PATENT

**REMARKS**

#### **Specification Amendments**

2-STEP INITIAL EQUALIZATION TRAINING  
FIG. 60

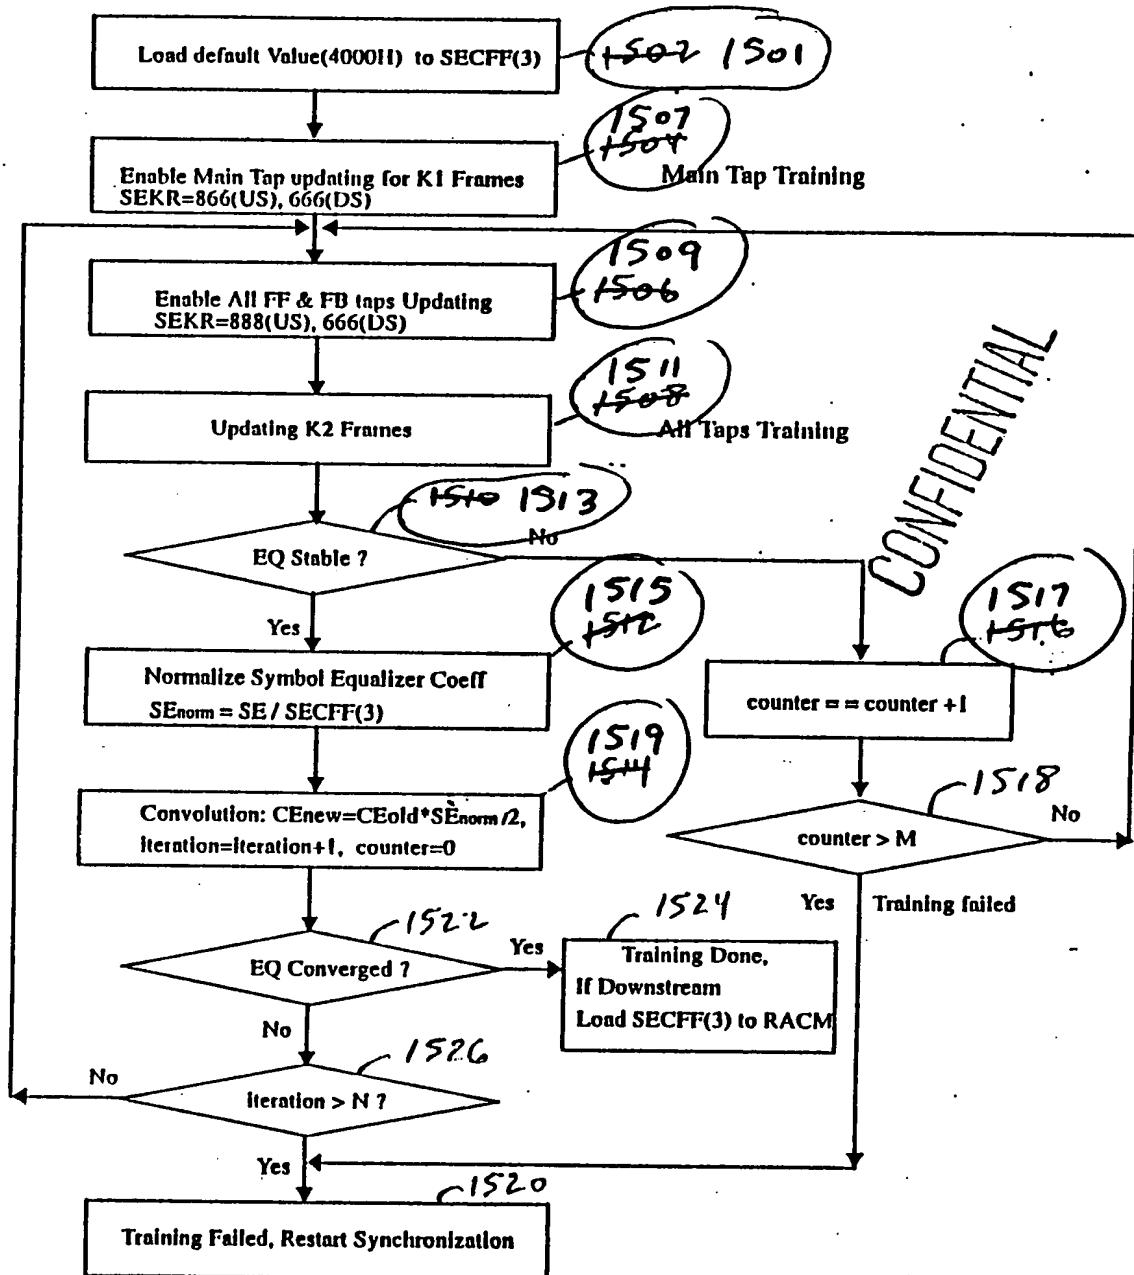
The amendment at page 144, line 8 conforms the description of step 1124 in the upstream equalization process embodiment of Figure 53B for the CDMA specific transmitters disclosed herein to step 1514 of the process of Figure 60 which is an equalization process which is useful in any distributed digital data system with multiple transmitters transmitting to a single central transceiver transmitter over different paths regardless of the type of multiplexing in use. Those skilled in the equalization art would realize that the original description of step 1124 was erroneous in not mentioning convolving the old coefficients with the new coefficients. Further, the software appendices of the parent case, U.S. patent application entitled "APPARATUS AND METHOD FOR SCDMA DIGITAL DATA TRANSMISSION USING ORTHOGONAL CODES AND A HEAD END MODEM WITH NO TRACKING LOOPS", serial number 08/895,612, filed 7/16/97, define a system with remote transceiver and central transceiver modems that act in this way. This amendment should not raise new matter issues, but if the Examiner disagrees, the courtesy of a telephone call to the undersigned is respectfully requested.

circuit but must, instead, be convolved with the old CE circuit coefficients to generate the new CE coefficients. Further, this amendment conforms the description of the process of Figure 53C to the process described in Figure 60 and the accompanying text. Further, the software appendices of the parent case, U.S. patent application entitled "APPARATUS AND METHOD FOR SCDMA DIGITAL DATA TRANSMISSION USING ORTHOGONAL CODES AND A HEAD END MODEM WITH NO TRACKING LOOPS", serial number 08/895,612, filed 7/16/97, define a system with remote transceiver and central transceiver modems that act in this way. This amendment should not raise new matter issues, but if the Examiner disagrees, the courtesy of a telephone call to the undersigned is respectfully requested.
